## Objection to Proposed Shop Top Housing Development at Pymont Bridge/Parramatta Road (SSD-84024470 – 122-128, 130 Pymont Bridge Road, 206 Parramatta Road, Annandale).

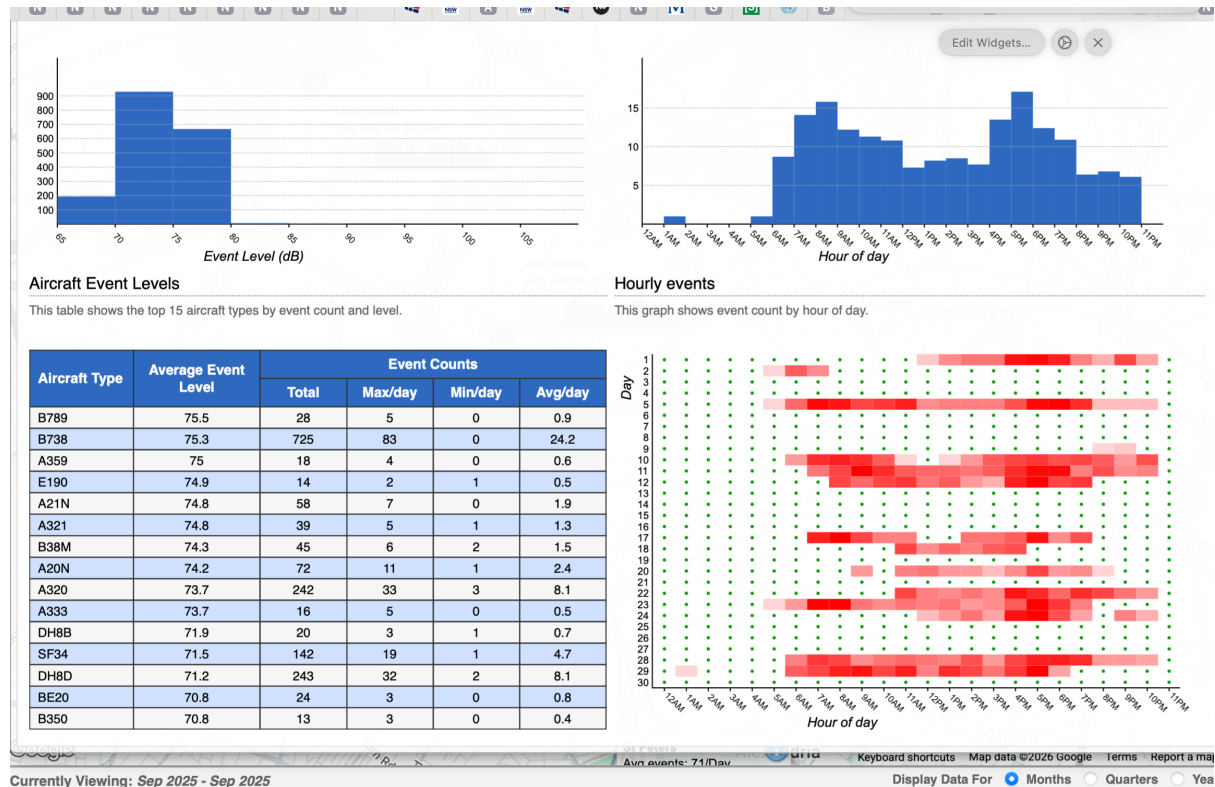
The FlightRadar App shows aircraft flying at a height of 320 meters over the site. The ground elevation of 14 meters plus development height means that planes will fly only around 225 metres above the building. The site is proposing the highest tower of all local proposed developments. This is concerning in the context of existing PANS OPS heights as shown in the EIS .(Appendix E p52)
